**RE: Broadstone Highlands North Block
Grading and Drainage Plan
Engineer's Stamp Date: 10/12/17
Hydrology File: K15D034A**

Re: Broadstone Highlands North Block / Hydrology File K15D034A

Enclosed for your review and comment is a re-submittal of Broadstone Highlands North Block Grading & Drainage Plan. Please see the responses to your comments dated 09/13/17 below:

PROPOSED STREET SECTIONS

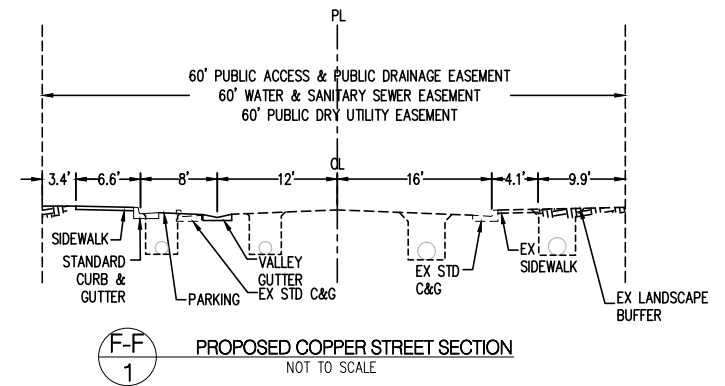
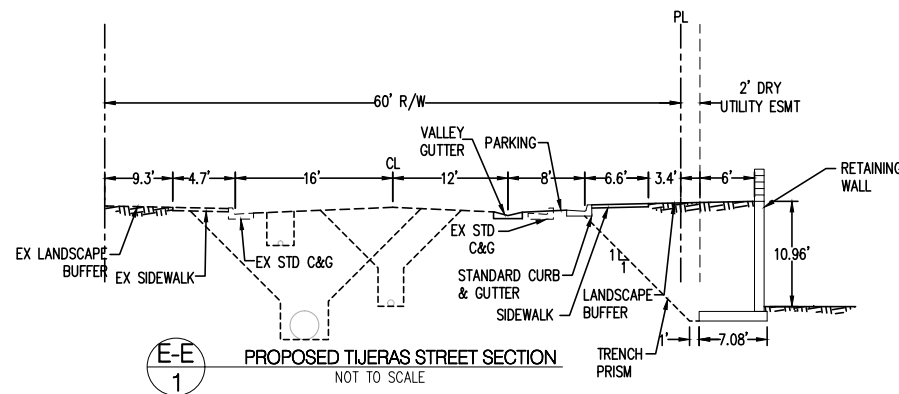
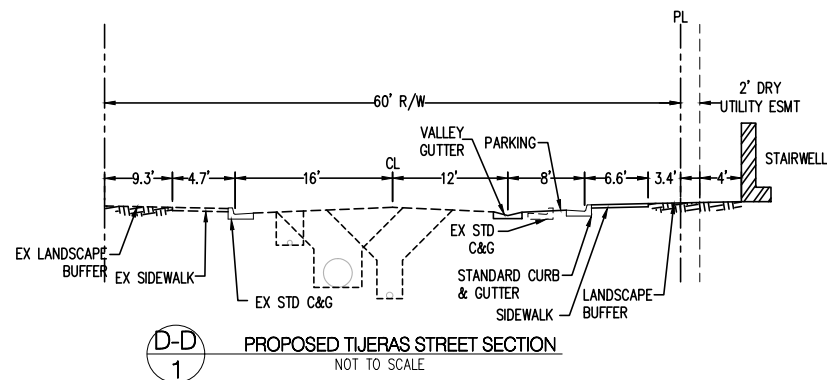
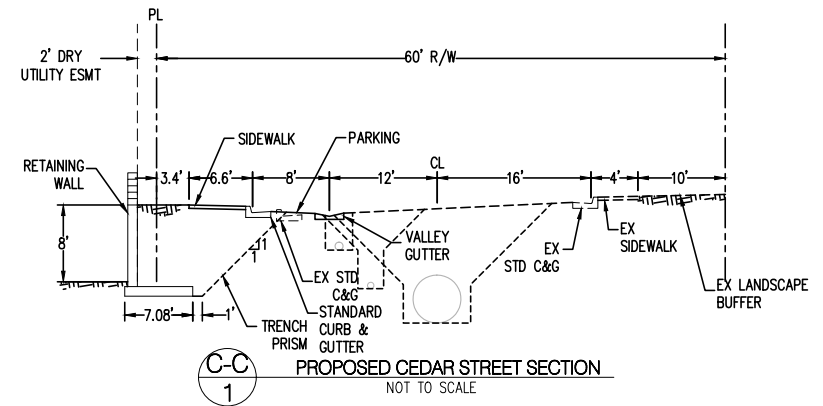
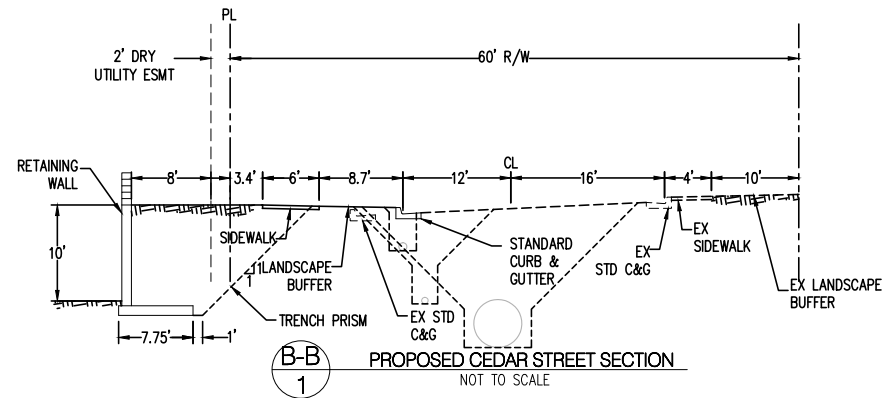
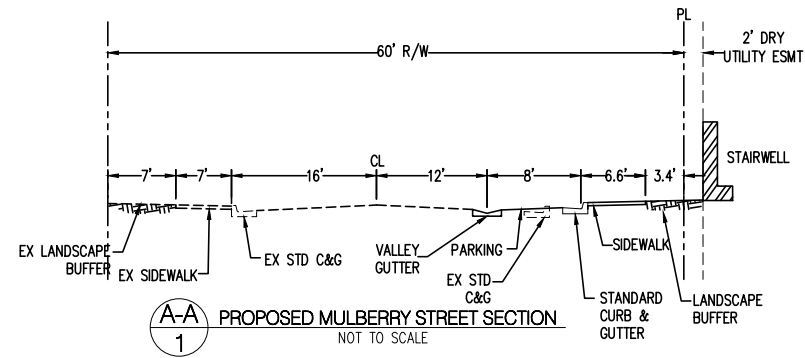
1. Provide multiple section views of the retaining walls along Tijeras, Cedar, and Copper to ensure that adjacent properties and ROW are not damaged or constrained in their use by these walls (per DPM Ch.22.5.B). These sections views should show the following:
 - a. Wall and footer, including dimensions and retained height.
 - b. ROW and easements.
 - c. Underground utilities and their trenching prisms.
 - d. Existing structures, such as sidewalk, curb and gutter, and roadway.
 - e. Temporary slope during construction.

Response: Please see the attached "Proposed Street Sections" exhibit.

DRAINAGE
MANAGEMENT PLAN

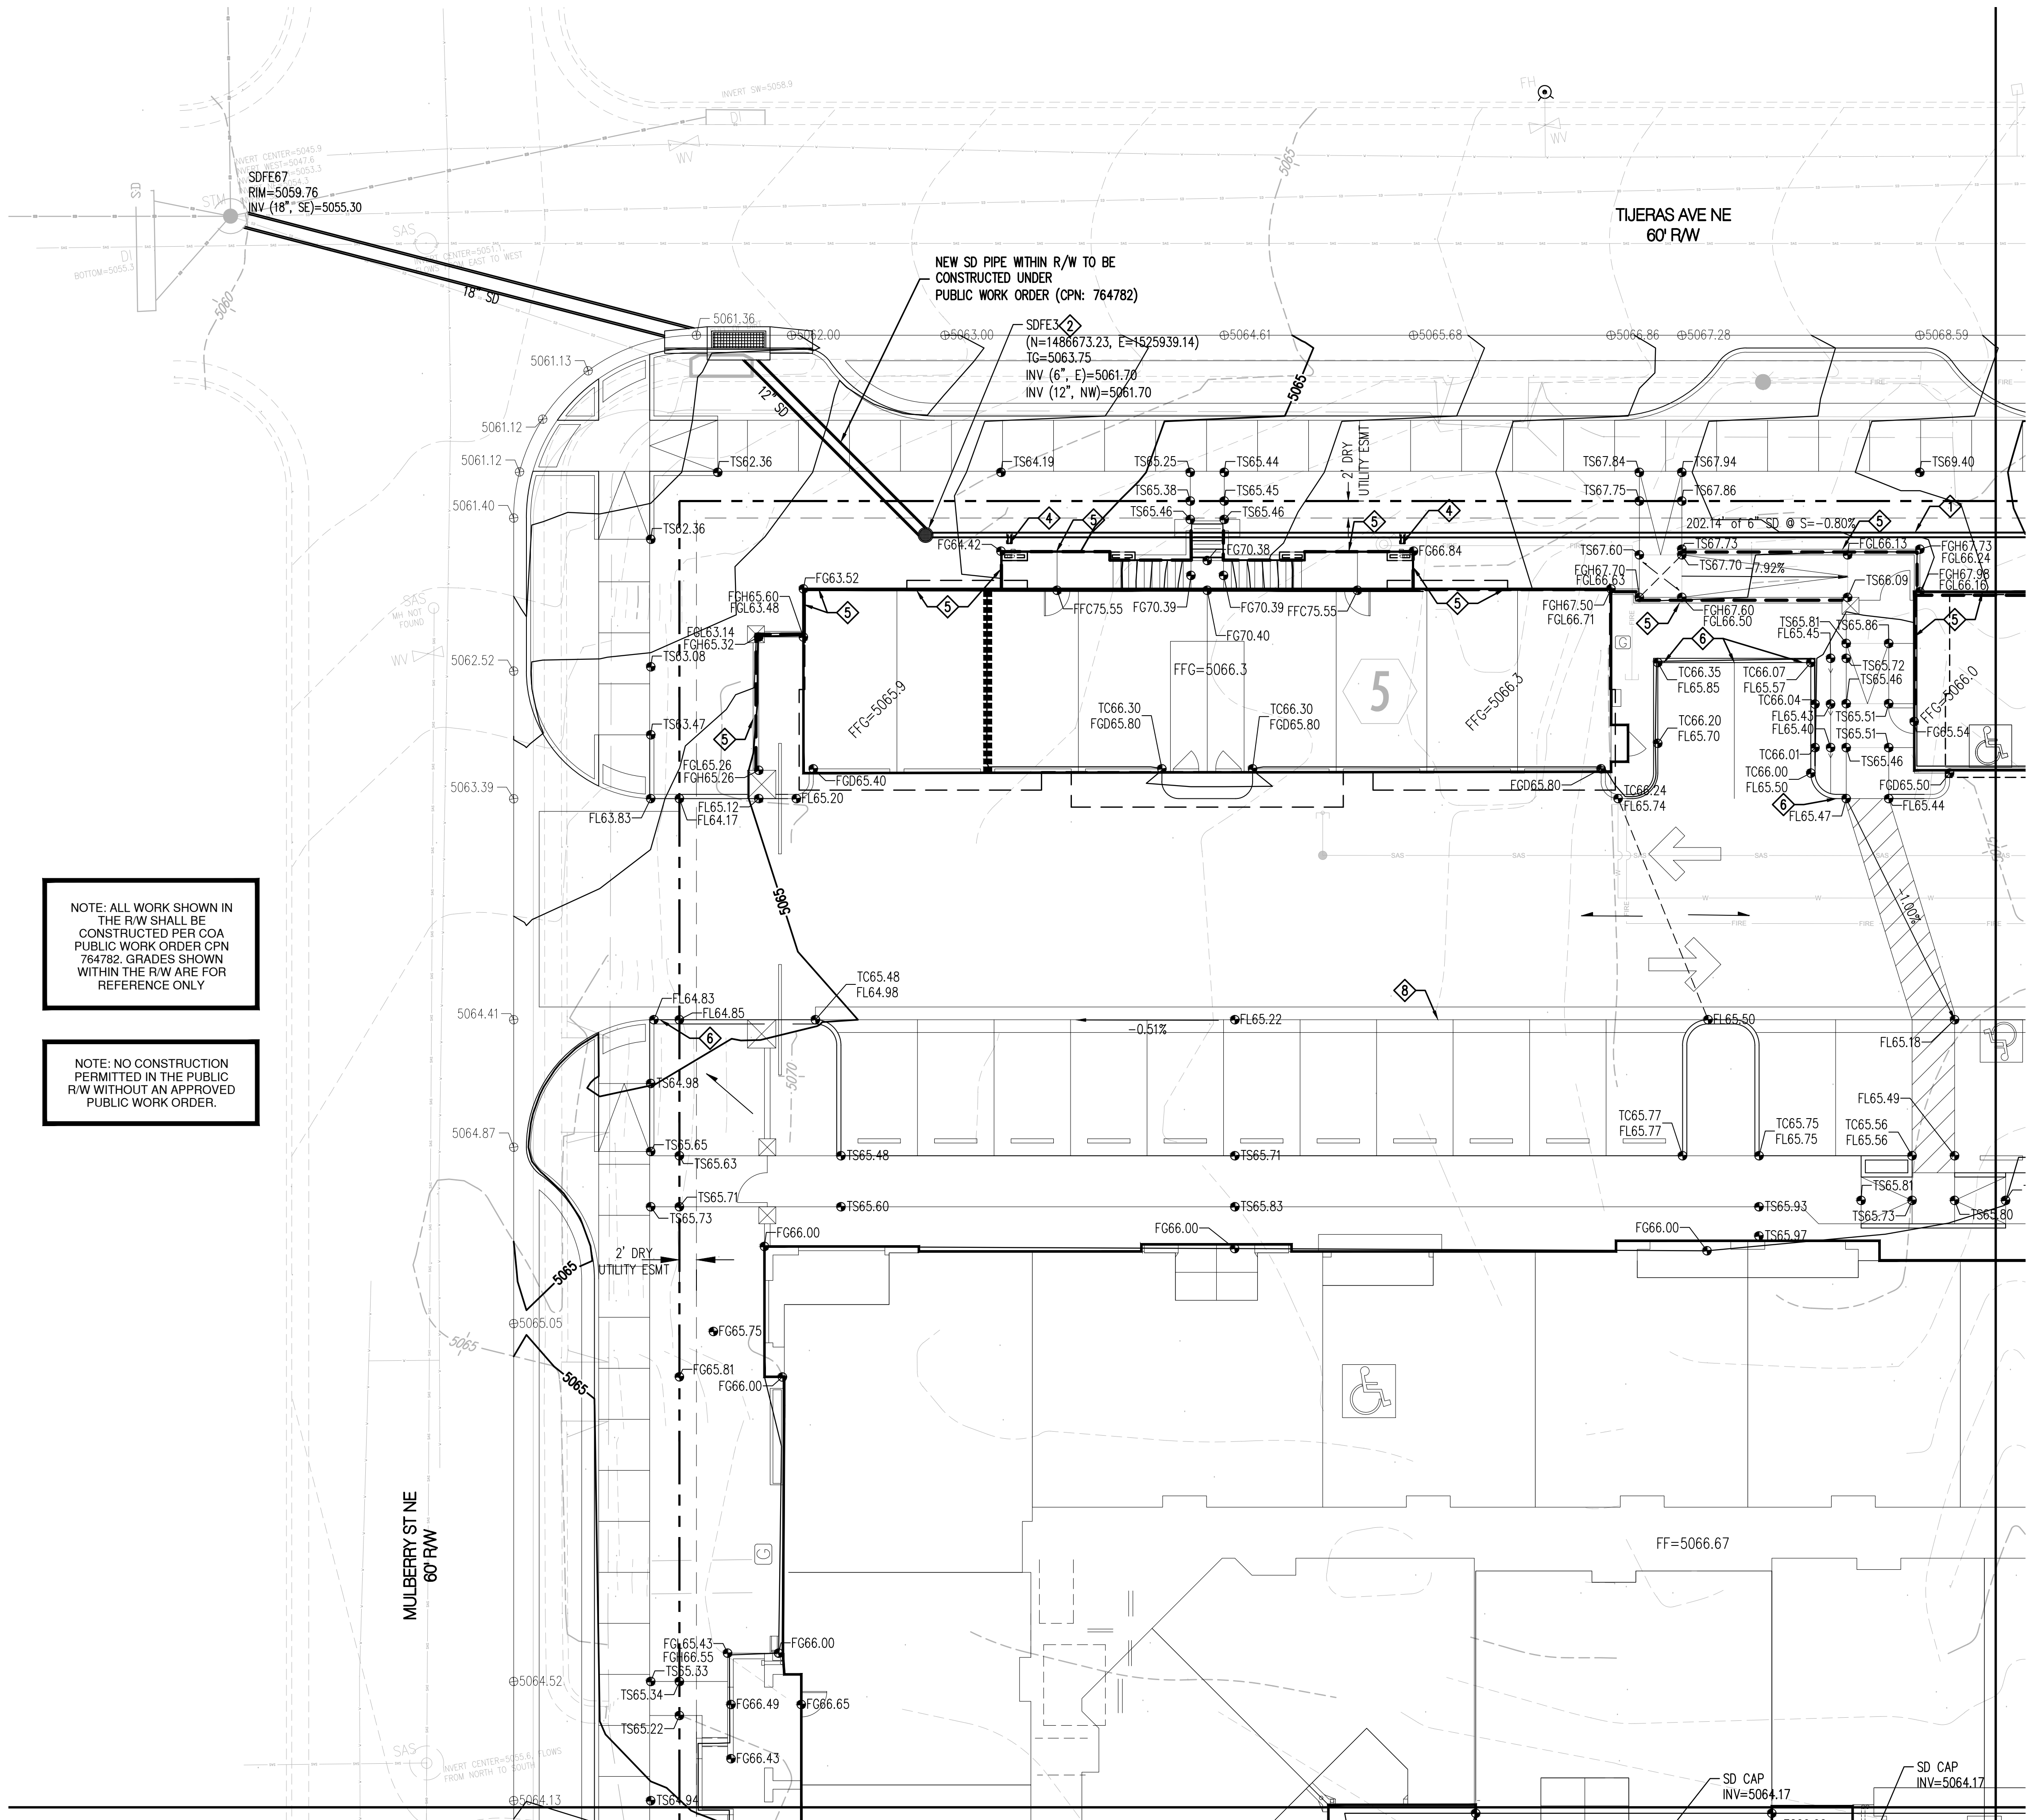
1. This project requires an ESC Plan, submitted to the Stormwater Quality Engineer (Curtis Cherne PE, ccherne@cabq.gov).
2. A revocable permit for the footer encroachment into the Cedar St public ROW is required.
3. Construction plans for work in the public ROW need be to be submitted to DRC for review.
4. Payment of the Fee in Lieu (Amount = $2,664\text{CF} \times \$8/\text{CF}$, per sheet C0.01) for the required first flush volume must be made.

3. Provide size/type information for all ROW drainage improvements.

Response: The sizes/types of drainage infrastructure has been indicated on the Drainage Management Plan.

OVERALL
GRADING PLAN

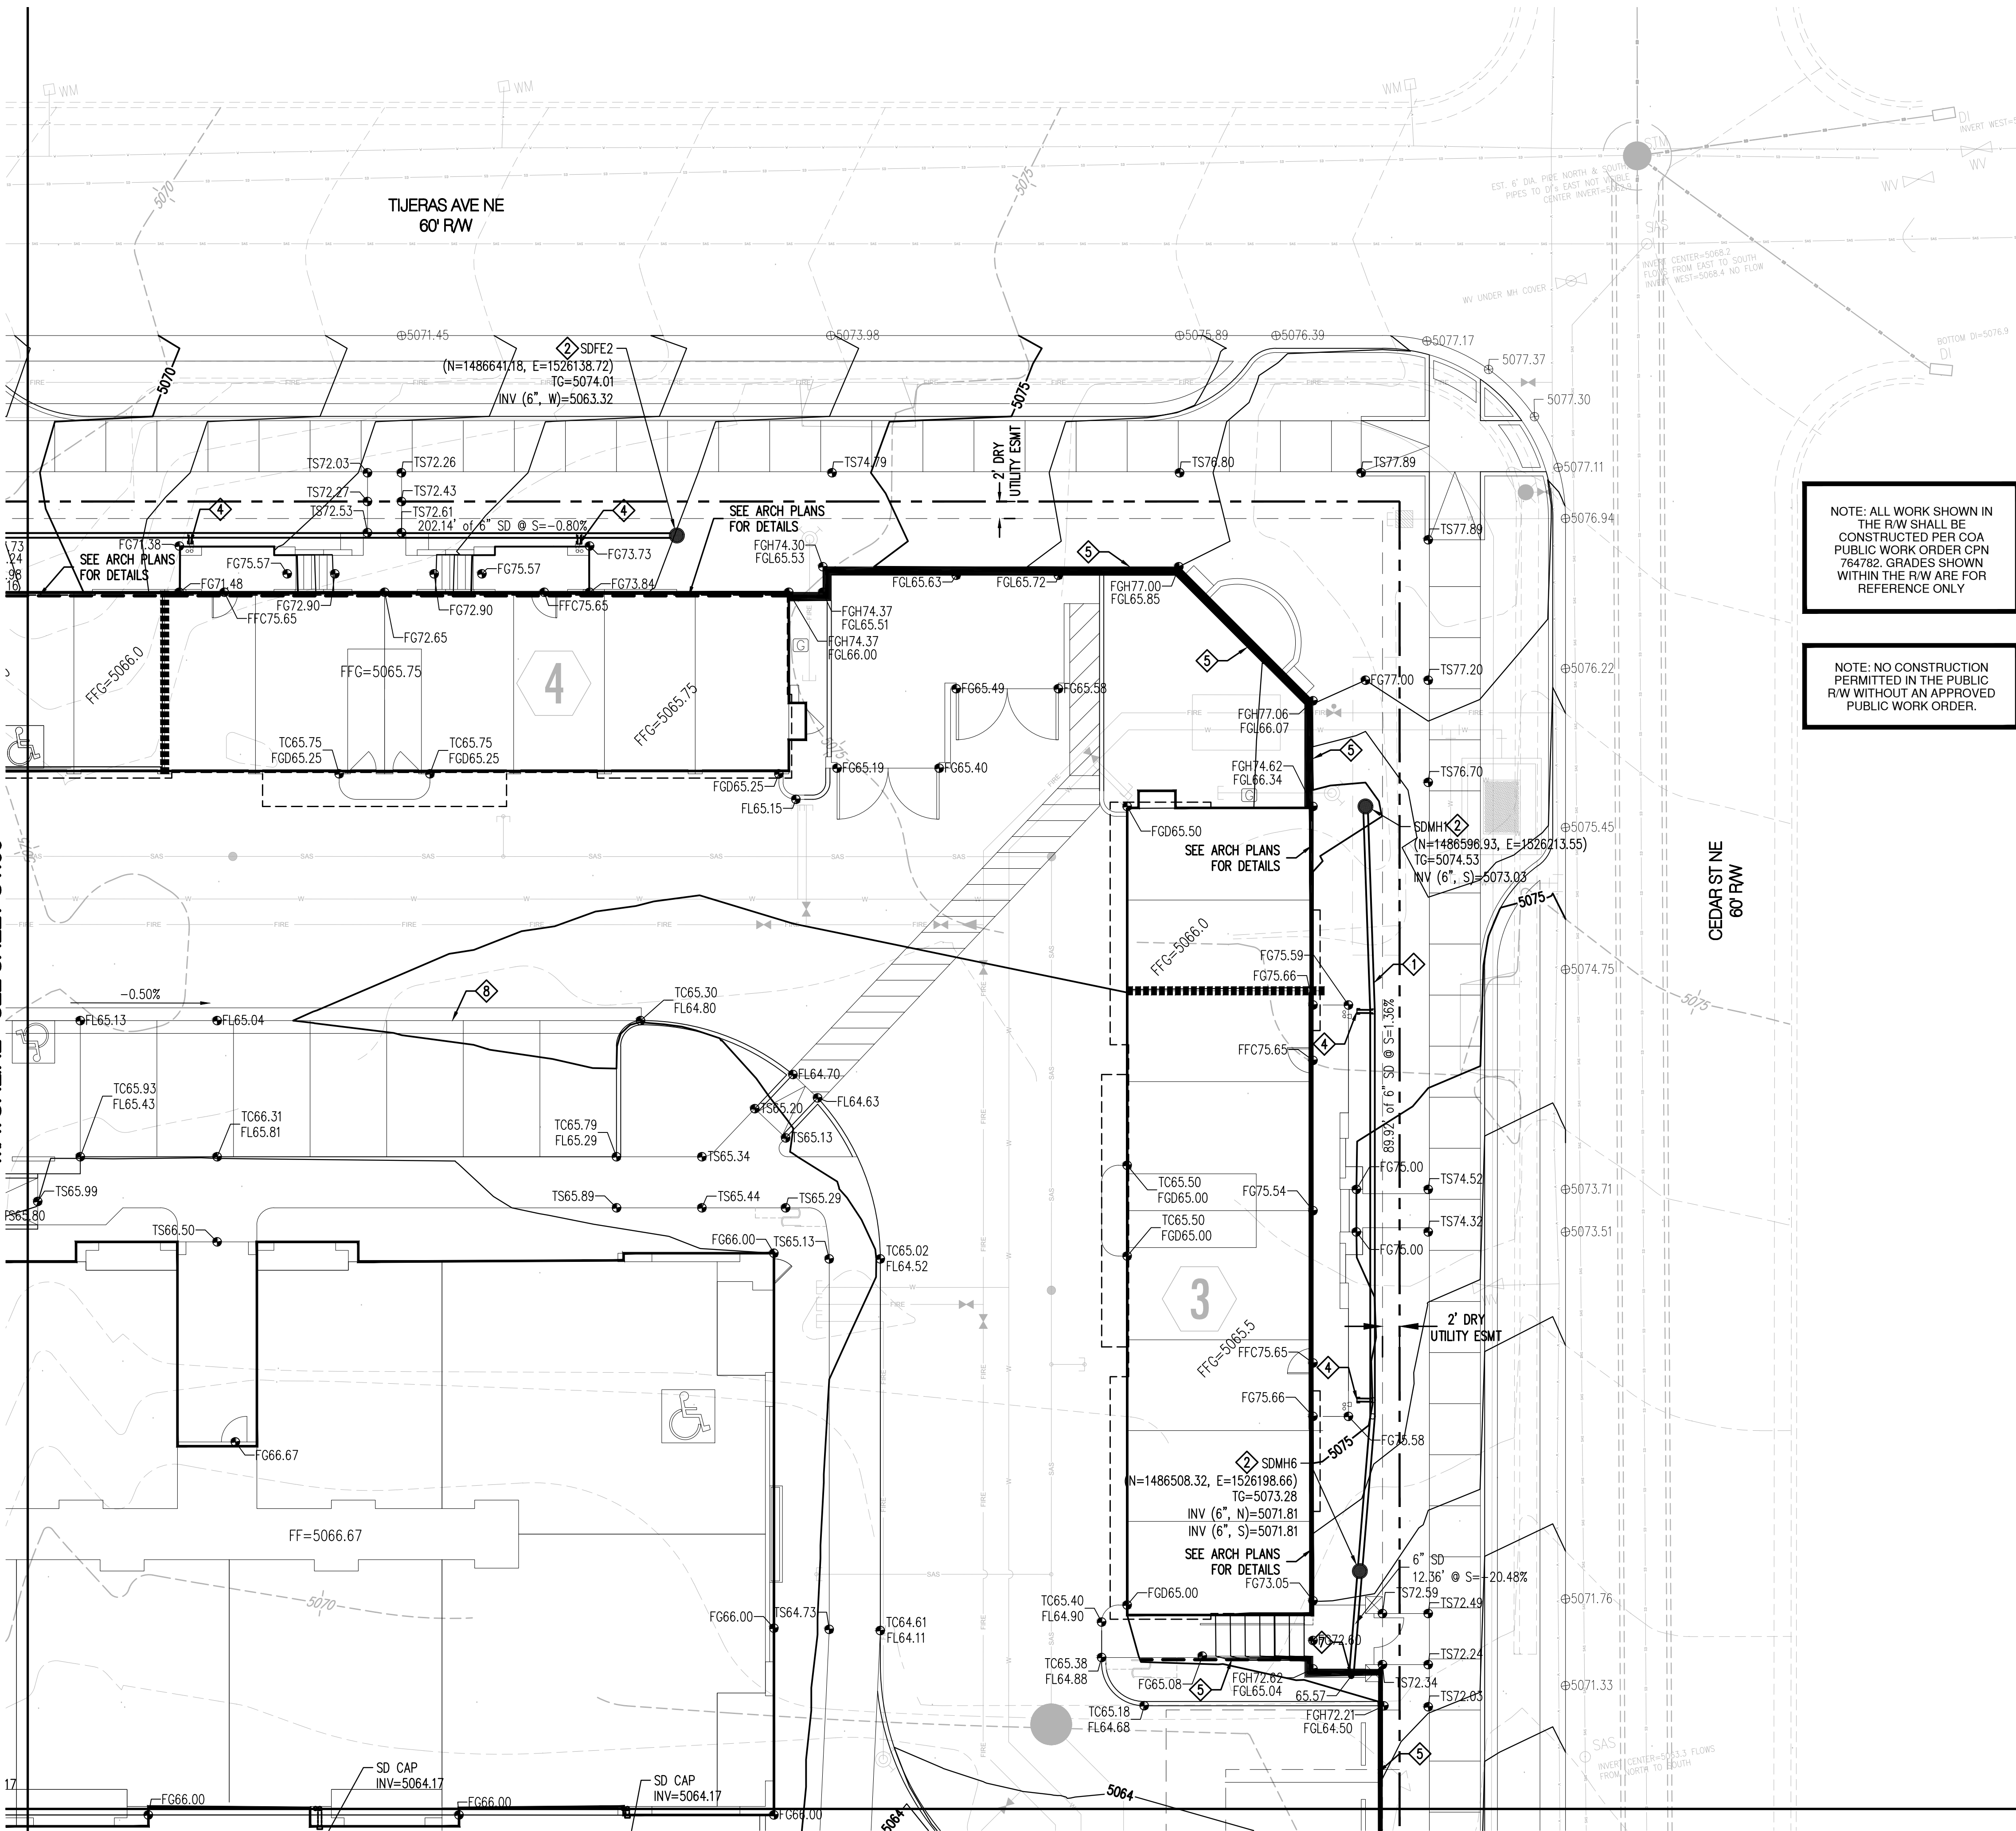
4. For the drop inlet replacement at the northwest corner, the 12" storm drain line will need to be replaced to the manhole with an 18" storm drain line, similar to what's being done at the southwest corner inlet.

6. Include note on grading plan: "No construction permitted in public ROW without an approved Work Order."

Response: The existing 12" storm drain line at the northwest corner of the site will be replaced with a new 18" storm drain line as requested. Please see grading plan.

Response: This note has been added to the grading plan.
